EPB AGENDA SUMMARY

APPLICATION: #2919, David Viera

LOCATION: 66 Shelter Rock Road - Lot N15 **ZONE:** RA-1

PROPOSAL: The applicant is proposing to maintain an existing concrete patio and to construct a new deck and staircase above proximate to wetlands on property located within the drinking water supply watershed of the Mianus River East Branch at 66 Shelter Rock Road.

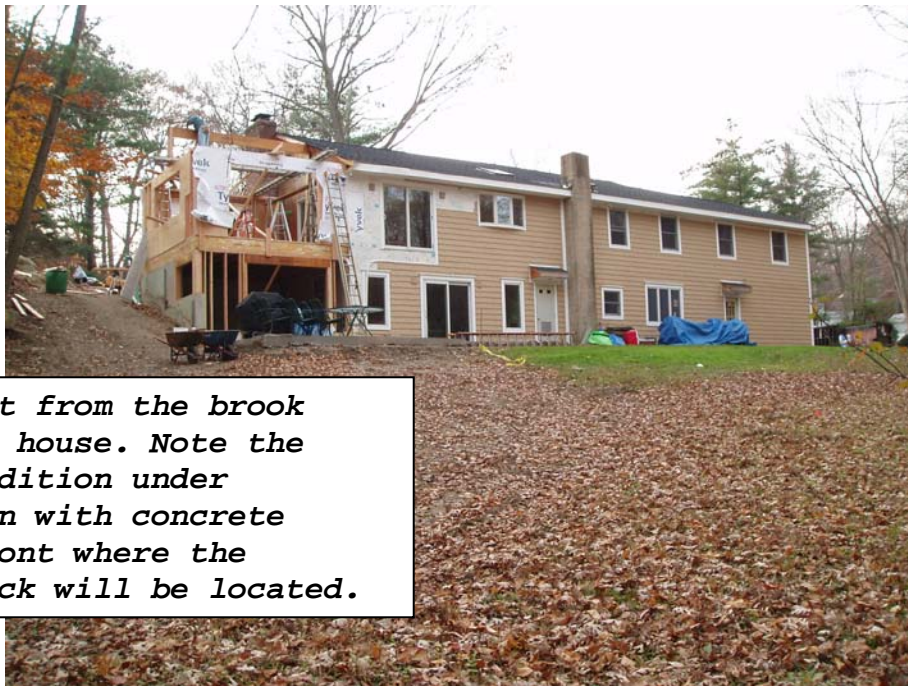
EPB staff is concerned with the long term impact on nearby wetlands from the proposed activities and the effective control of erosion and sedimentation during and immediately following the installation of the deck and stairs. These concerns are adequately addressed in the following paragraph.

The long term impact from the approximately 240-square-foot area of disturbance is expected to be negligible. However, the western portion of the wetlands and buffer is almost void of vegetation. Therefore, a planting plan for the enhancement of this area is warranted and should be made a condition of approval.

RECOMMENDATION: If the Board elects to approve the application, staff recommends the following conditions for consideration:

- 1.) Submission of a planting plan to EPB staff for review and approval;
- 2.) All landscaping improvements to be completed under the supervision of qualified professionals with certification of proper completion provided to EPB staff prior to inspection;
- 3.) Standard bond or other acceptable surety for the installation of erosion controls, landscaping, and professional certifications, with a 15 percent contingency, to be filed with the EPB. An estimate is to be prepared by the permittee and submitted to EPB staff for review and approval;
- 4.) Notification of staff no less than 48 hours prior to the start of work, and submittal of a standard Contractor's Compliance form;
- 5.) A Standard Landscape Maintenance Agreement to be filed on the Stamford Land Records;
- 6.) A Permit Filing Fee of \$53.00, and Annual Permit Compliance Fee of \$200.00 to be submitted to staff within 15 days.
